April 13, 2015

**Subject: Century Tire Plaza – 195 Kennebec Street
Project ID# 2015-027
Review Comments Received April 8, 2015**

PROJECT CENTURY TIRE PLAZA 195 KENNEBEC STREET, PORTLAND, ME	
SHEET TITLE DETAILS		CLIENT NORTHLAND ENTERPRISES, LLC	DRAWN: KCS DESIGNED: ADJ CHECKED: ADJ FILE NAME: SP-M160 DETAILS
REVISIONS		DATE DESCRIPTION	DATE: 11.25.14 SCALE: NTS JOB NO.: SP-M160 SHEET: C-7.1

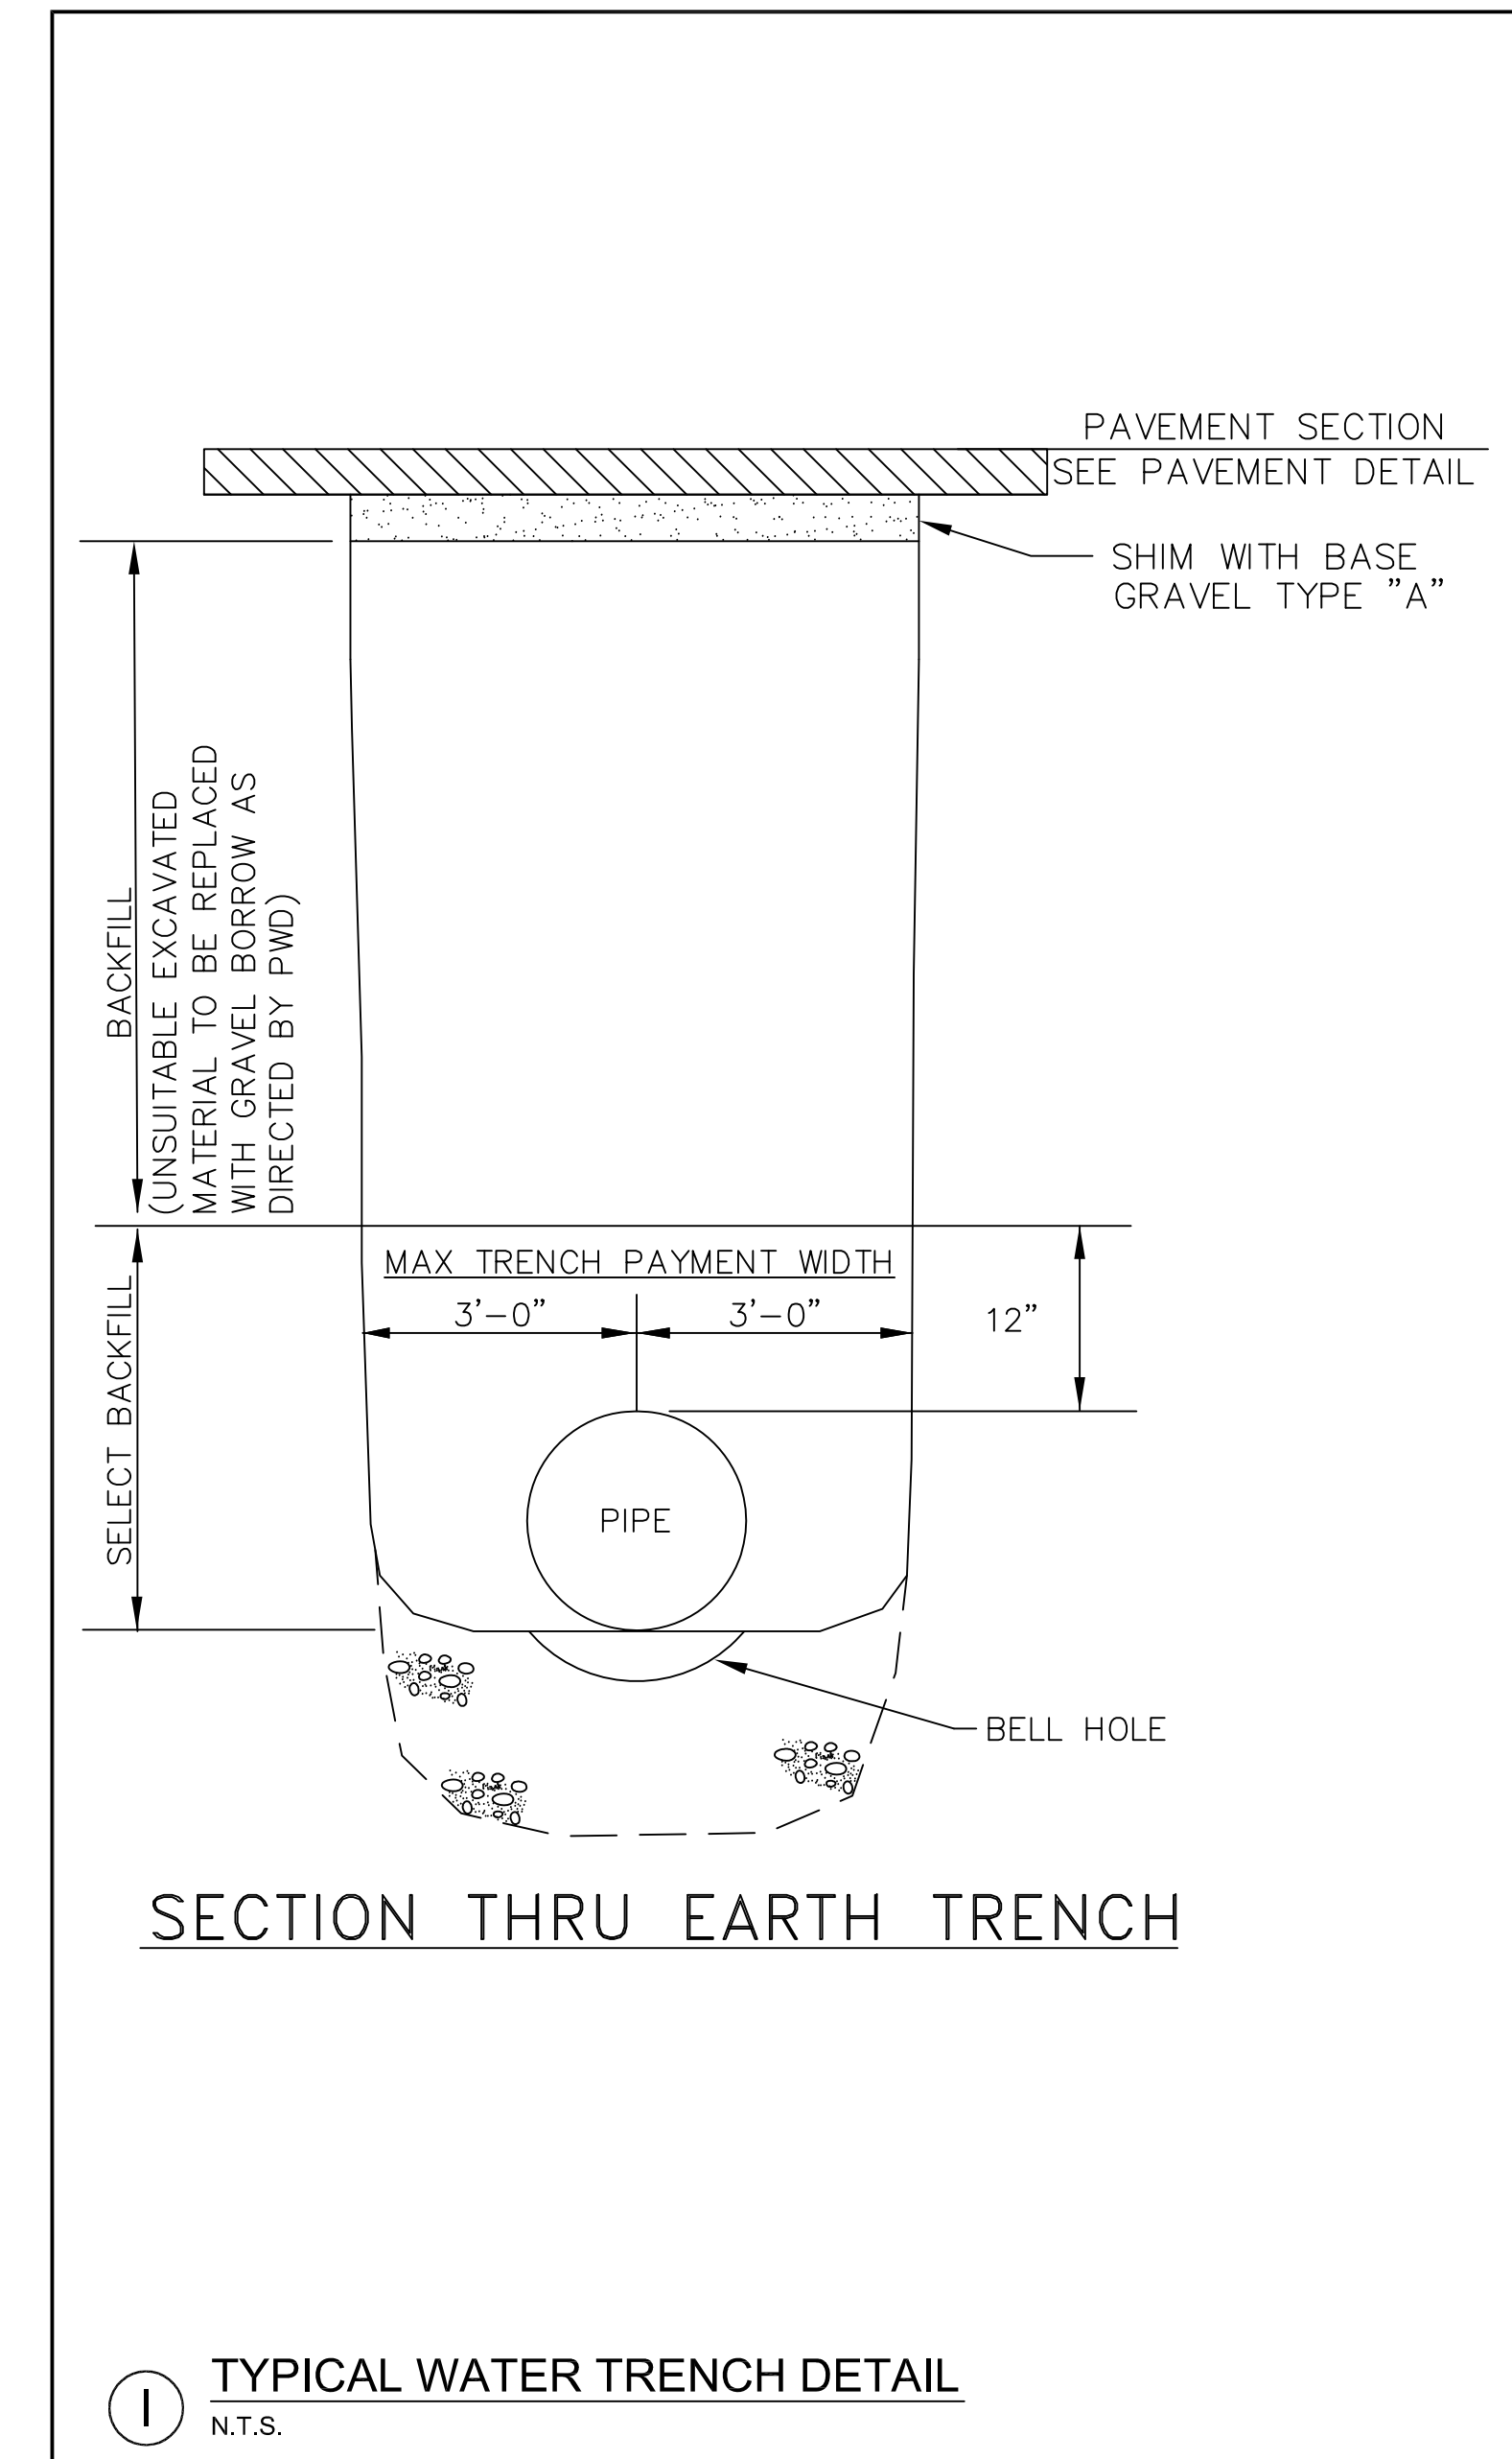
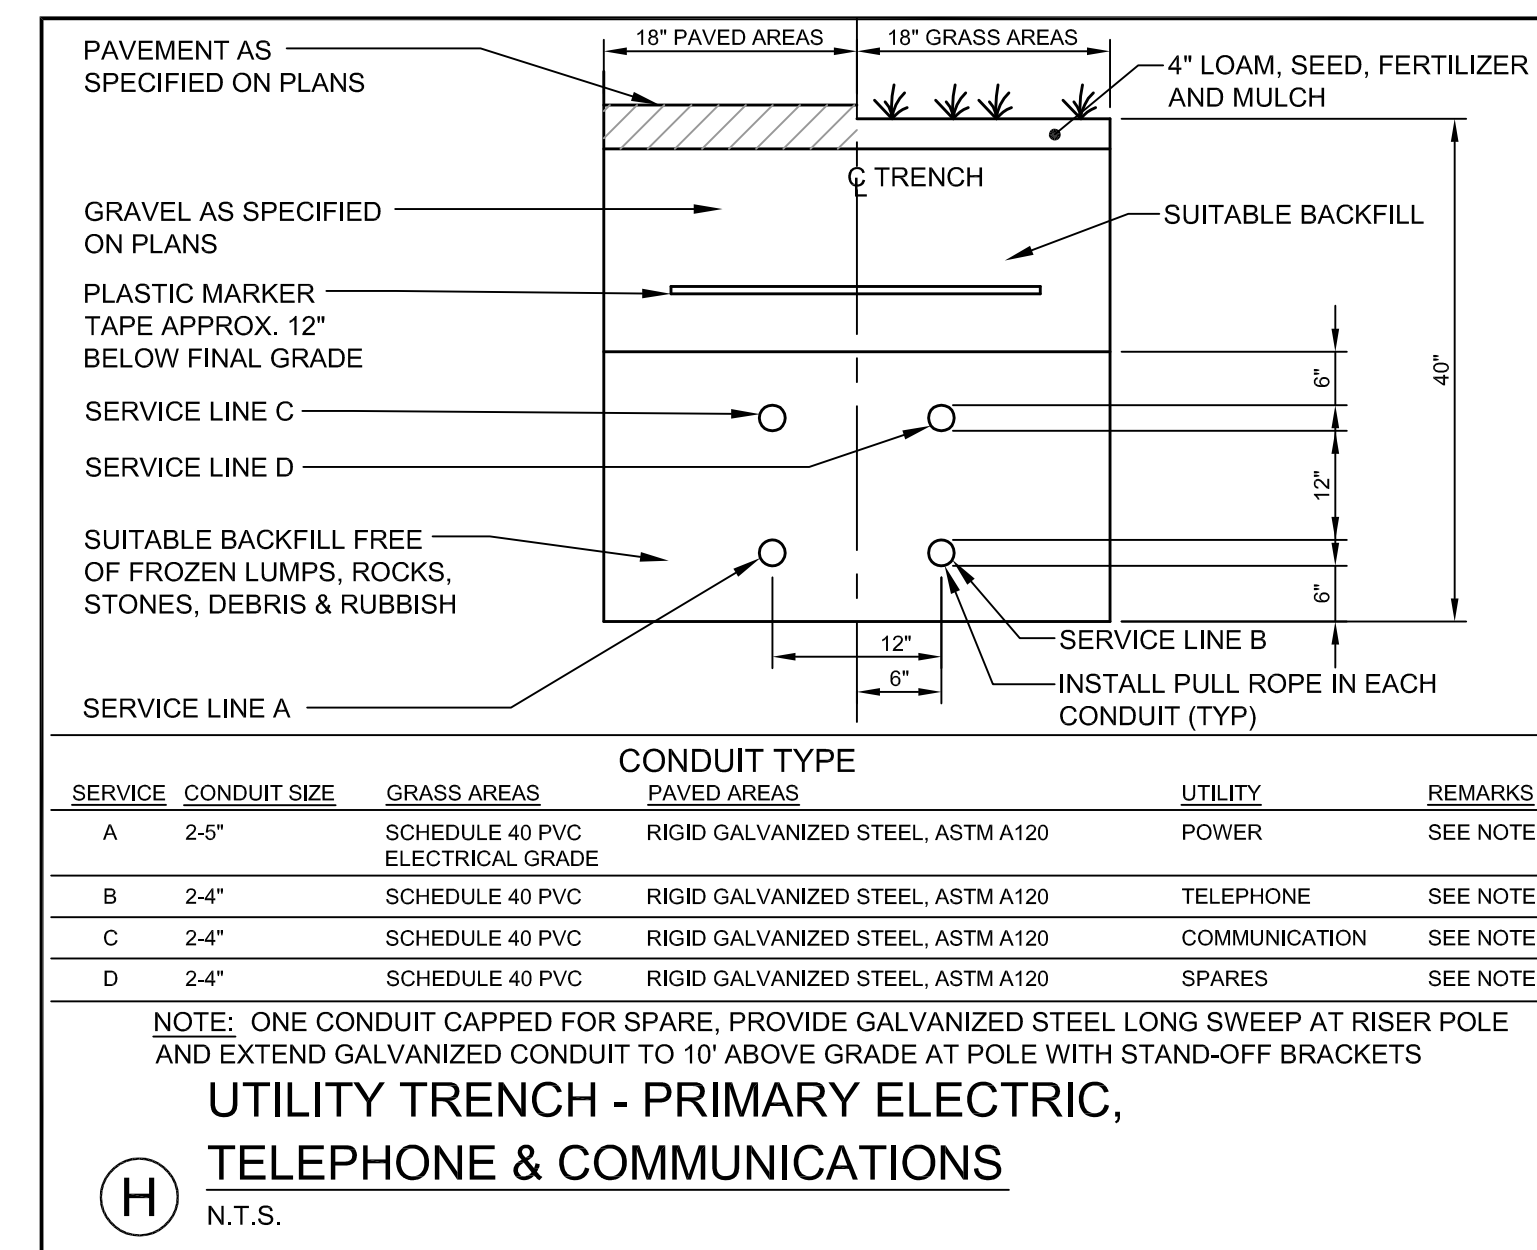
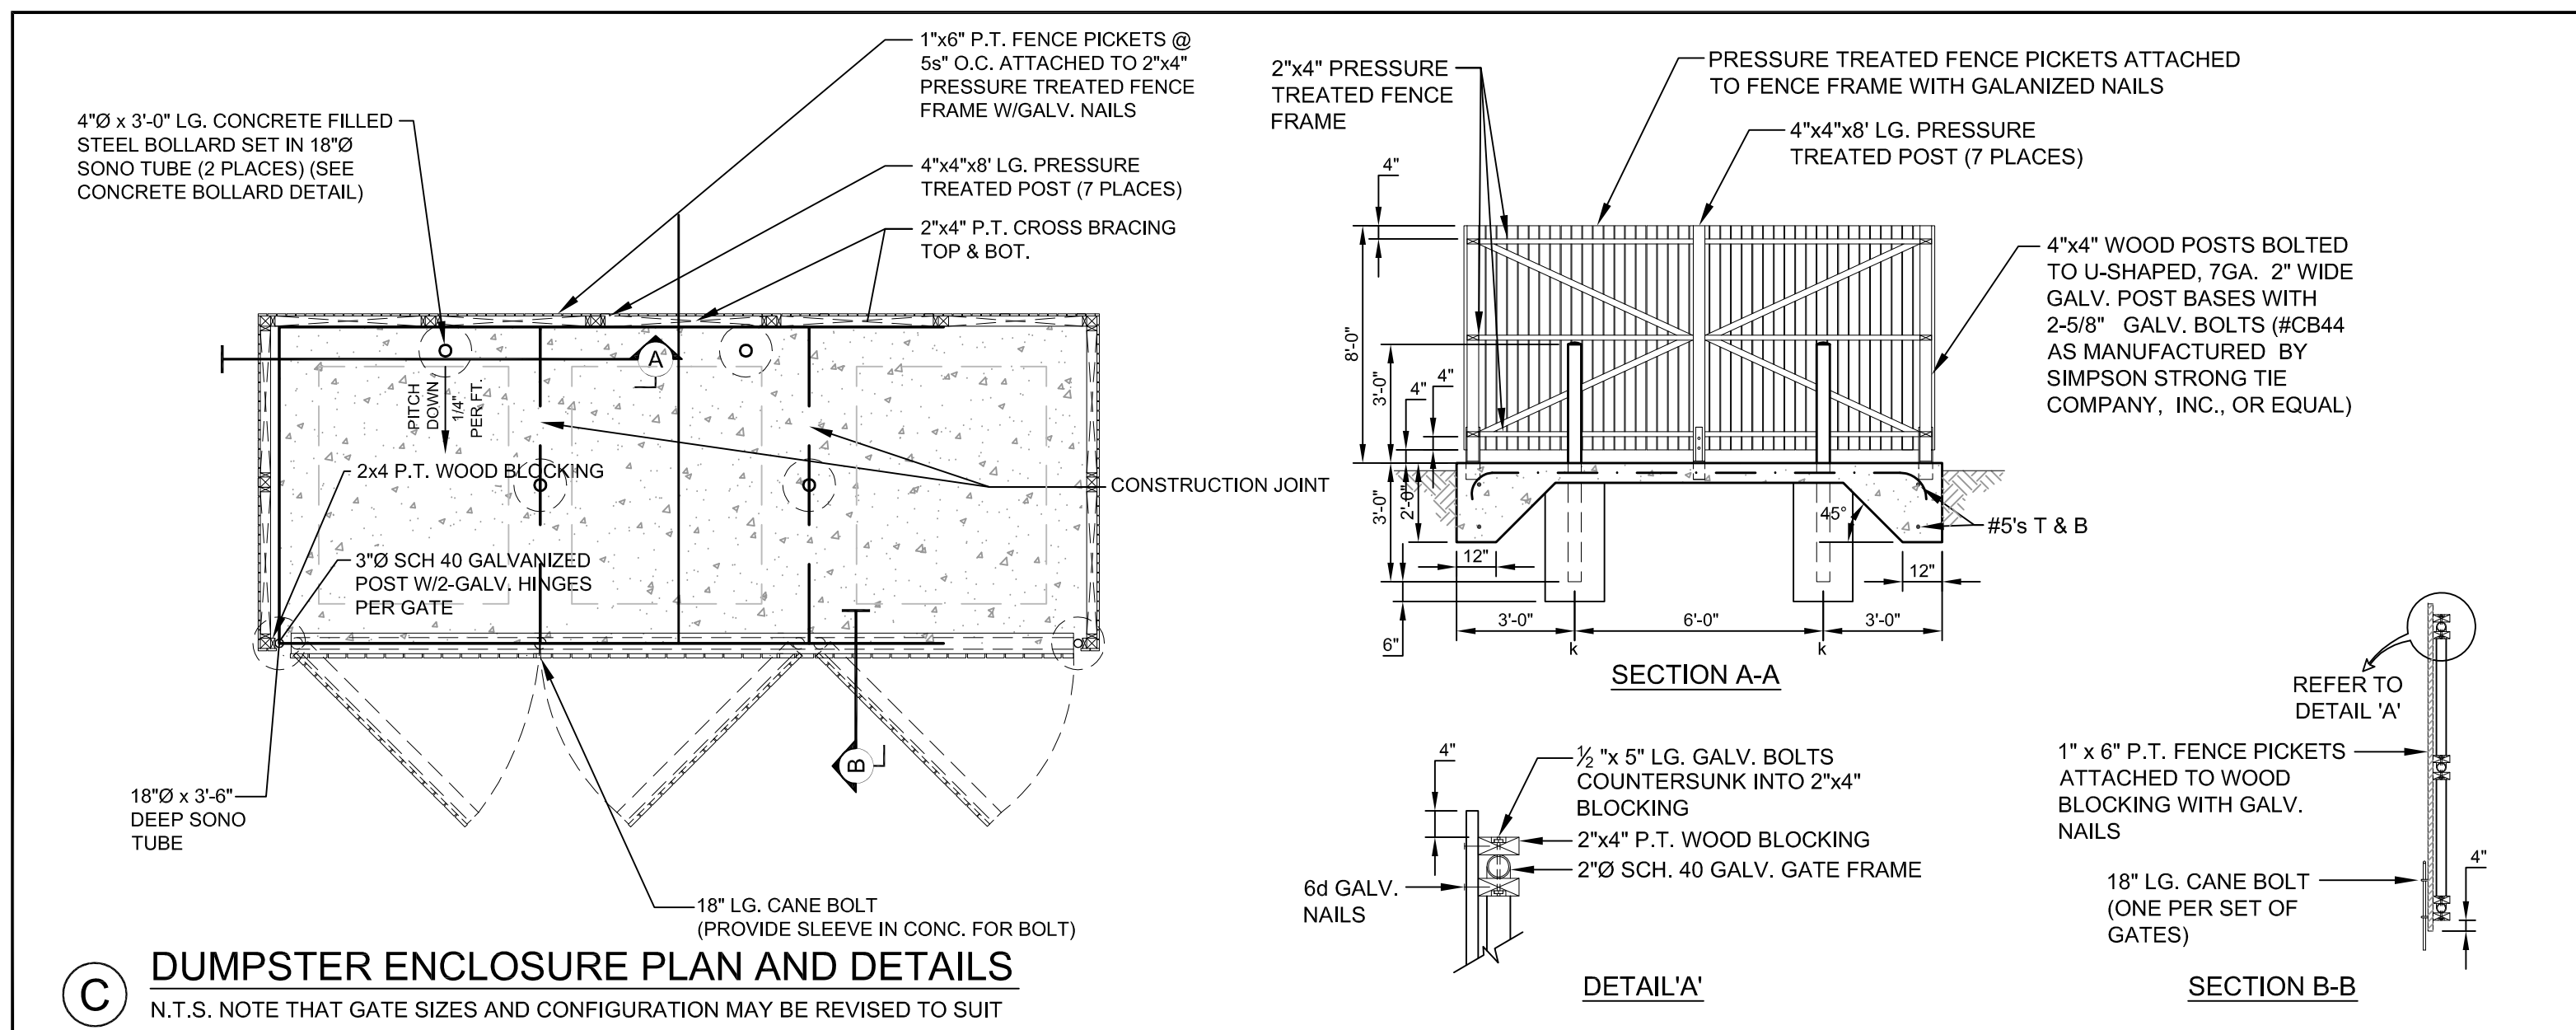
Detail A on plan sheet C-7.1 shows a curb reveal of 6 inches along Kennebec Street. The City standard for curb reveal is typically 7 inches. The curb reveal should be changed to match the City standard unless there are over-riding considerations that require a 6 inch curb reveal. A change to 6 inch curb reveal may require changing the specification for granite curb terminal pieces from 6 feet to 7 feet in length.

The curb reveal dimensions have been amended on the revised plan sheets.
